TECHNICAL BULLETIN

JAR OPS 3 MODIFICATION

* Supersedes TB900-014R3, dated 15 March 2001. Revised to reflect the change in nomenclature for part number 90005720002 and the title change of Technical Bulletin TB900-010R1, due to the part number change for the Integrated Instrument Display System (IIDS). Aircraft which have complied with previous revisions of this Bulletin meet the intent of this revision.

All MD900 helicopters serial number 00010 thru 00051 equipped with Pratt & Whitney PW206A engines.

Figure 1. A612 Forward Interconnect Panel Modification (Sheet 1 of 3)

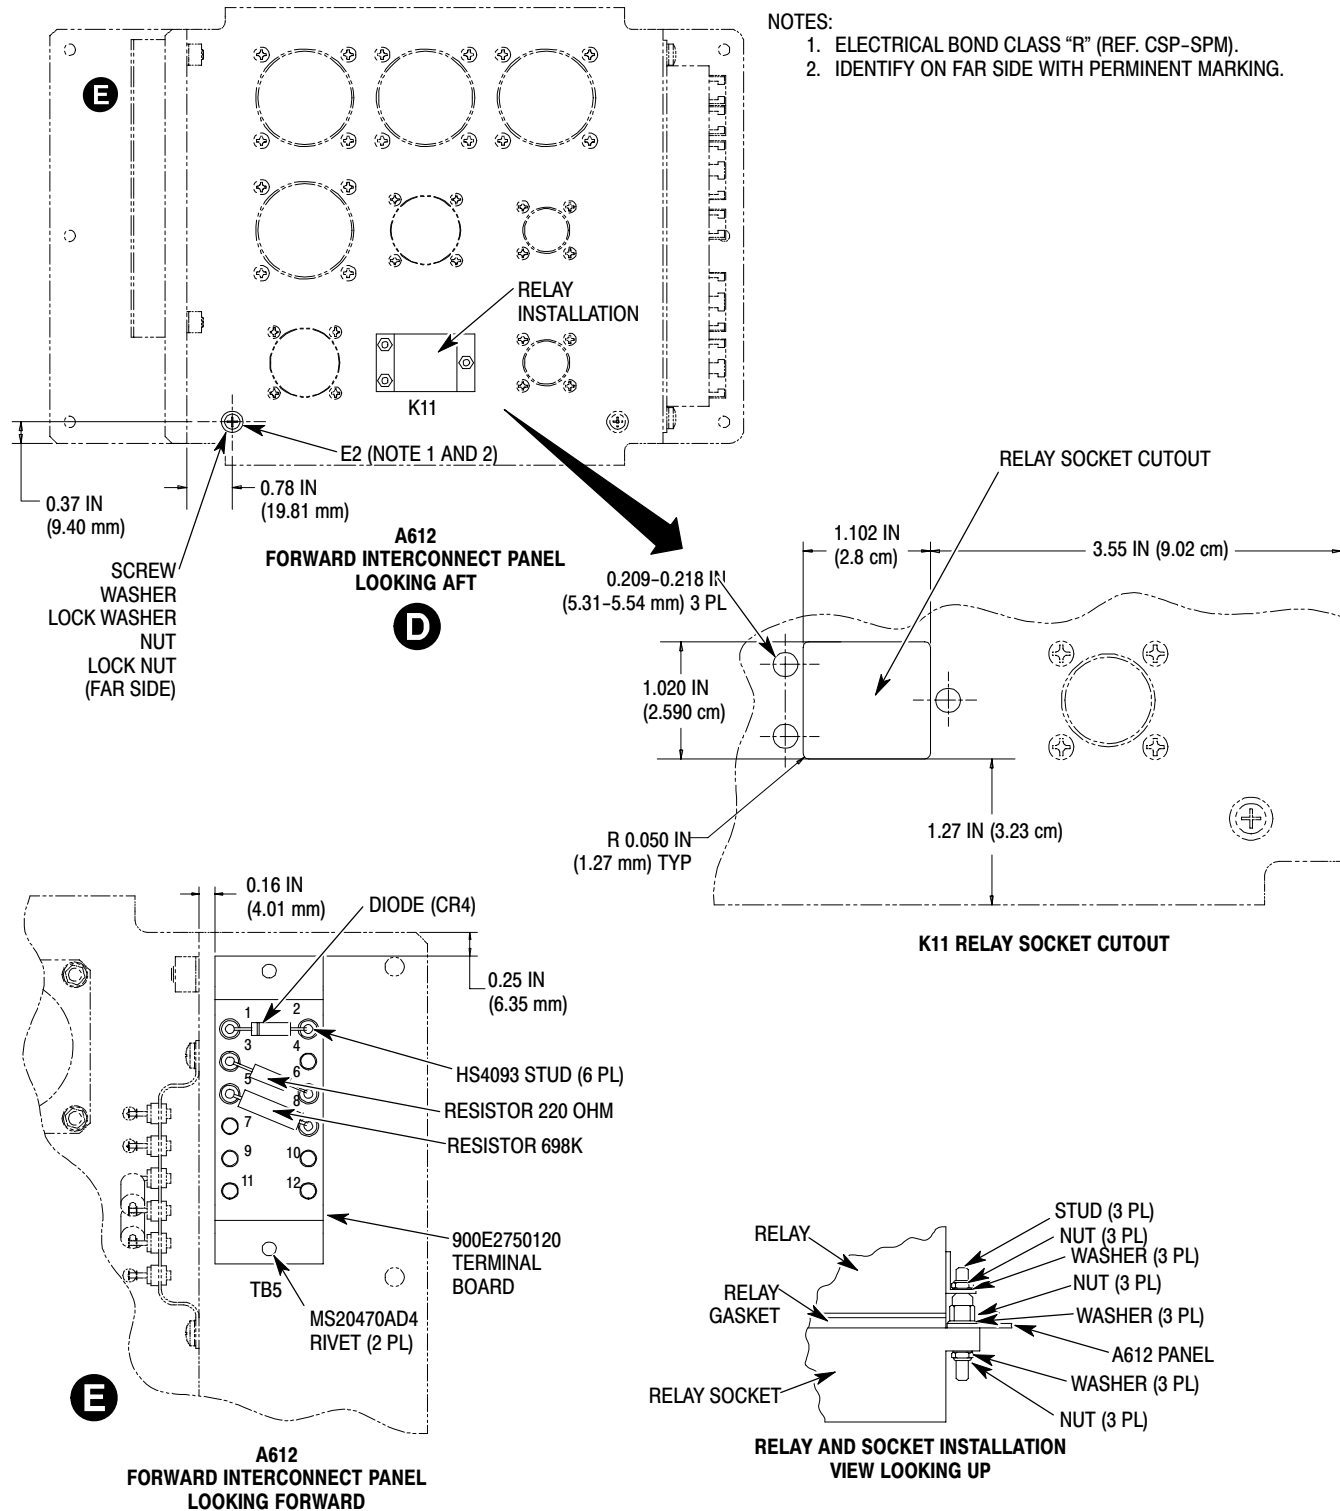
- (3). Stencil new S9 switch legend as shown using block font with a height of 0.08 in (2.03 mm) minimum. Paint new legend using HMS15-1100 white paint.
- (4). Install GO and NO-GO lights.
 - (a). Blackout "PUSH TO TEST" with HMS15-1100 black paint.
 - (b). Remove instrument panel glareshield (Ref. CSP-900RMM-3).
 - (c). Locate position of lights approximately as shown.
 - (d). Remove encoding altimeter (Ref. CSP-900RMM-3).

- (e). Drill holes with a number 40 drill and enlarge to **0.470 - 0.490 in ()** and deburr.

- (g). Touch up with primer (C310) (Ref. CSP-SPM).
- (h). Install lamp holders and lamps (Ref. CSP-900RMM-3).
- (i). Install "NO-GO" and "GO" labels as shown.

- (b). Locate the 900E2750630 bracket as shown in figure and drill three (3) equally spaced number 30 holes through bracket and aircraft structure.
- (c). Deburr holes and electrical prep bracket and structure for class R electrical bond (Ref. CSP-SPM).

- (d). Install bracket using NAS1919 rivets. Install wet with primer (C310).
- (e). Electrical bond prep bracket and HS4785 track assembly for class R electrical bond (Ref. CSP-SPM).
- (f). Install track assembly using four (4) NAS603-8P screws, eight (8) AN960JD10L washers, and four (4) MS21042L3 nuts. Torque hardware (Ref. CSP-900RMM-2).
- (g). Test track for class R electrical bond (Ref. CSP-SPM).
- (h). Install two (2) HS4791-1 relay sockets into track assembly (Ref. CSP-900RMM-3).

Figure 1. A612 Forward Interconnect Panel Modification (Sheet 3 of 3)

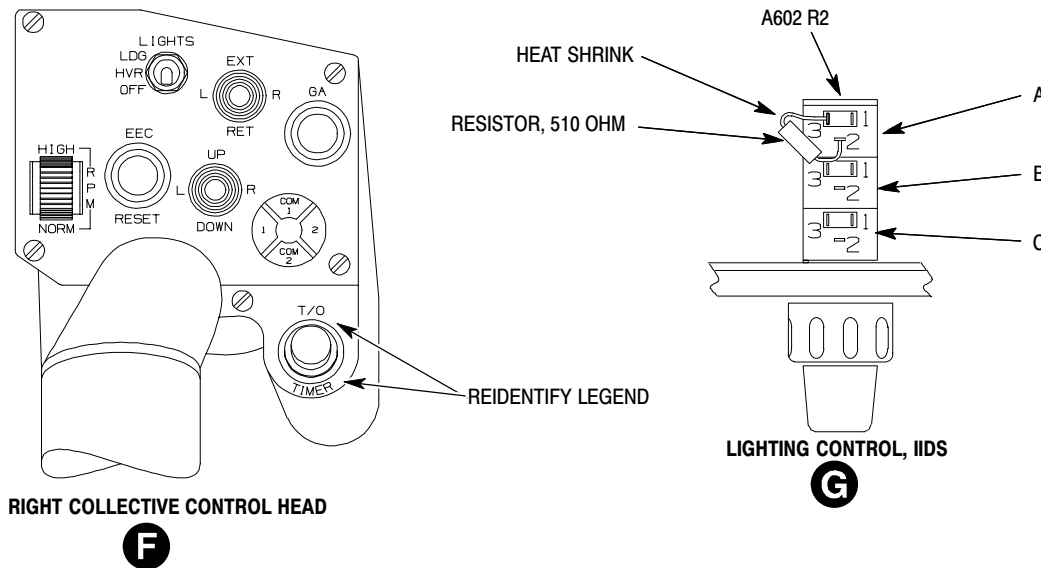
- (6). Modify A612 forward interconnect panel.

- (d). Drill three relay mounting holes with a number 4 drill bit and deburr.
- (e). Cutout relay mounting clearance hole and deburr.
- (f). Drill TB5 mounting holes with a number 30 drill bit and deburr.

- (h). Install TB5 with two (2) MS2047AD4 rivets. Install wet with primer (C310).
- (i). Touch up K11 cutout and mounting holes with primer (C310) (Ref. CSP-SPM).
- (j). Install K11 relay socket using supplied hardware. Torque hardware.

- (k). Mark location of ground stud E2 and drill with a number 18 drill bit and deburr.

- (l). Prepare ground stud location E2 for class R electrical bond (Ref. CSP-SPM).
 - (m). Install MS51957 Screw, 3 ea. AN960JD6L washers, MS35338 spring lock washer, NAS671 nut, and MS21042L06 nut.

- (n). Test E2 for class R electrical bond (Ref. CSP-SPM).
 - (o). Identify E2 location with reference designator using permanent ink.
 - (p). Install power rectifier diode CR4 onto TB5-1 and TB5-2.

- (q). Install 220 ohm resistor onto TB5-3 and TB5-6, or if Bulletin was previously complied with prior to Revision 3, replace existing 2.2 K resistor with 220 ohm resistor.

- (r). Install 698 K ohm resistor onto TB5-5 and TB5-8.
- (7). Modify A602 electrical/lighting control panel.
- (a). Remove A602 panel from center console (Ref. CSP-900RMM-3).

Figure 2. Take Off Timer Wiring Diagram (Sheet 1 of 2)

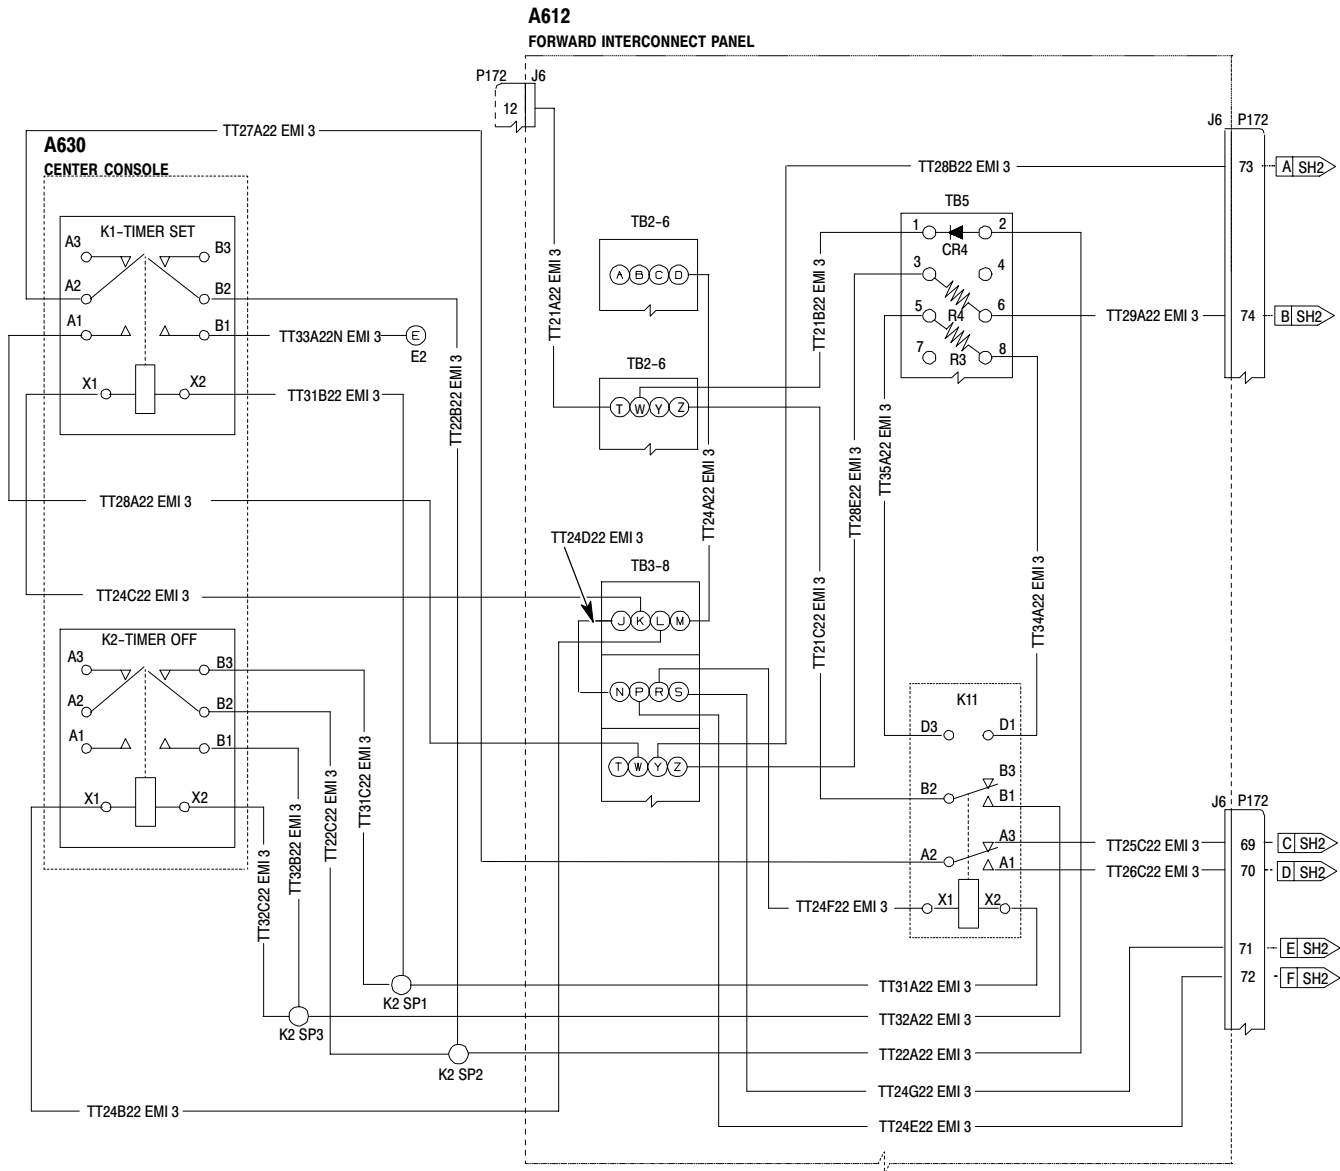
(8). Install new wiring into W124 wire harness.

- (a). Install wire TT28C22 EMI 3 from P172-73 to P116-F.
- (b). Install wire TT29B22 EMI 3 from P172-74 to P116-G.
- (c). Install wire TT30B22N EMI 3 from GS104-F to P116-H.
- (d). Install wire TT25B22 EMI 3 from P172-69 to J118-37.
- (e). Install wire TT26B22 EMI 3 from P172-70 to J118-36.
- (f). Install wire TT24K22 EMI 3 from P172-71 to J118-39.
- (g). Install wire TT24H22 EMI 3 from P172-72 to J118-38.

- (a). Install wire TT25A22 EMI 3 from P118-37 to NO-GO lamp holder (amber).
- (b). Install wire TT26A22 EMI 3 from P118-36 to GO lamp holder (green).
- (c). Install wire TT24N22 EMI 3 from P118-39 to GO lamp holder (green).
- (d). Install wire TT24M22 EMI 3 from P118-38 to NO-GO lamp holder (amber).

- (11). Install new wiring into A612 panel wire harness.
- (a). Remove wire E208B24 EMI 3 from J1-18 to TB2-6Z and discard.
 - (b). Install wire TT21A22 EMI 3 from J6-12 to TB2-6T.
 - (c). Install wire TT21B22 EMI 3 from TB2-6W to TB5-1.
 - (d). Install wire TT21C22 EMI 3 from TB2-6Z to K11-B2.
 - (e). Install wire TT24A22 EMI 3 from TB2-6D to TB3-8M.
 - (f). Install wire TT24D22 EMI 3 from TB3-8J to TB3-8N.

- (g). Install wire TT31A22 EMI 3 from K2-SP1 to K11-X2.
 - (h). Install wire TT22A22 EMI 3 from K2-SP2 to TB5-2.
 - (i). Install wire TT32A22 EMI 3 from K2-SP3 to K11-B1.

- (j). Install wire TT28B22 EMI 3 from TB3-8Y to J6-73.
 - (k). Install wire TT24F22 EMI 3 from TB3-8R to K11-X1.
 - (l). Install wire TT24G22 EMI 3 from TB3-8S to J6-71.

- (m). Install wire TT24E22 EMI 3 from TB3-8P to J6-72.
 - (n). Install wire TT28E22 EMI 3 from TB3-8Z to TB5-3.
 - (o). Install wire TT35A22 EMI 3 from TB5-5 to K11-D3.

- (p). Install wire TT34A22 EMI 3 from TB5-8 to K11-D1.
 - (q). Install wire TT29A22 EMI 3 from TB5-6 to J6-74.
 - (r). Install wire TT25C22 EMI 3 from K11-A3 to J6-69.

- (s). Install wire TT26C22 EMI 3 from K11-A1 to J6-70.
- (12). Reinstall A612 forward interconnect panel (Ref. CSP-900RMM-3).
- (13). Install wiring from A612 to K1/K2.

- (a). Install wire TT24C22 EMI 3 from K1-X1 to TB3-8K.
 - (b). Install wire TT28A22 EMI 3 from K1-A1 to TB3-8W.
 - (c). Install wire TT27A22 EMI 3 from K1-A2 to K11-A2.

- (d). Install wire TT33A22N EMI 3 from K1-B1 to E2.

Figure 2. Take Off Timer Wiring Diagram (Sheet 2 of 2)

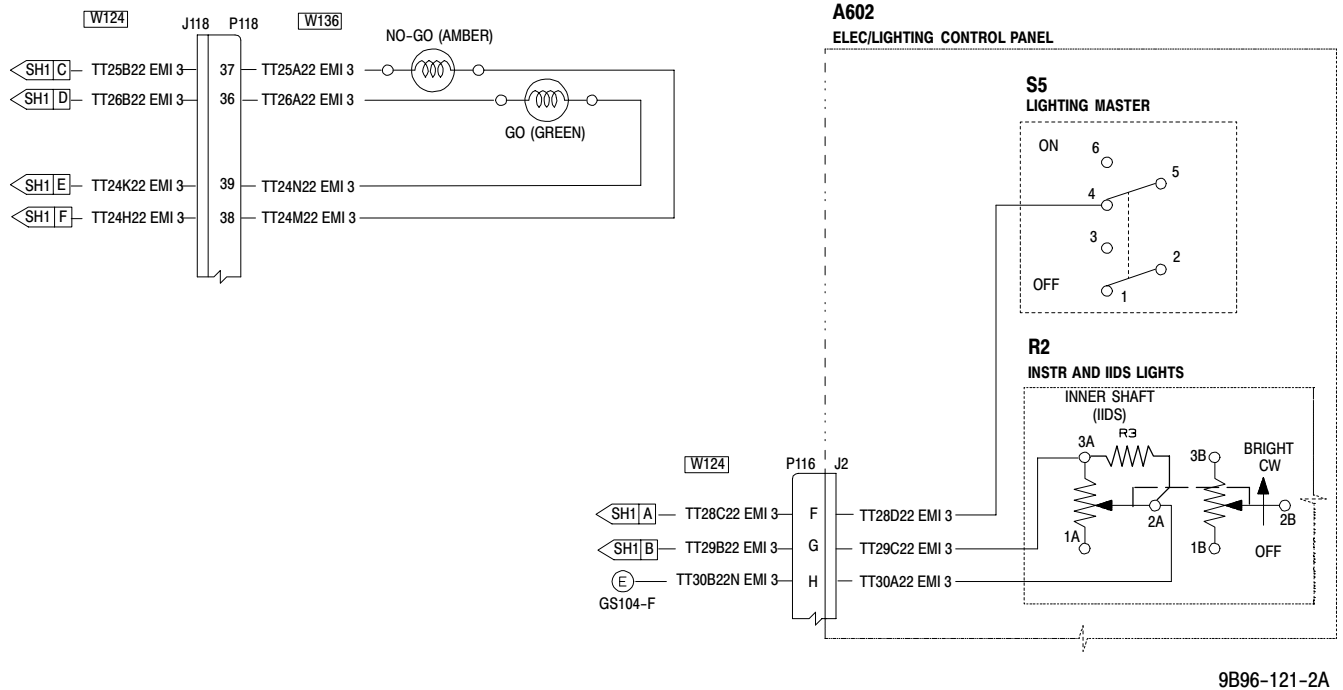
- (e). Install wire TT31B22 EMI 3 from K1-X2 to K2-SP1.
 - (f). Install wire TT31C22 EMI 3 from K2-B3 to K2-SP1.
 - (g). Install wire TT22C22 EMI 3 from K2-B2 to K2-SP2.

- (h). Install wire TT22B22 EMI 3 from K1-B2 to K2-SP2.
 - (i). Install wire TT32B22 EMI 3 from K2-B1 to K2-SP3.
 - (j). Install wire TT32C22 EMI 3 from K2-X2 to K2-SP3.

- (k). Install wire TT24B22 EMI 3 from K2-X1 to TB3-8L.
- (14). Install altimeter, glareshield, K11 relay, K1 relay, and K2 relay.
- (15). Secure all wiring.
